S303-12

TECHNICAL BULLETIN

Misfire/Non-Start – Water Ingress Into Spark Plug Wells – Revised On-Plug Coil Cover

MODEL 2000 MY S-TYPE

ILLUSTRATION 1

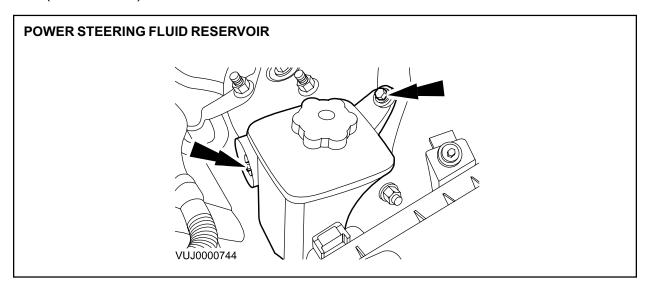
7. Remove the power steering fluid reservoir securing screws and displace reservoir (Illustration 1).

ILLUSTRATION 2

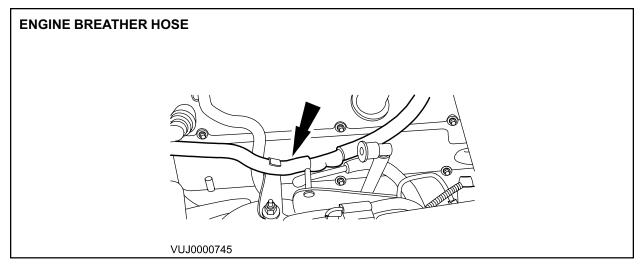
8. Release engine breather hose from securing clip (Illustration 2).
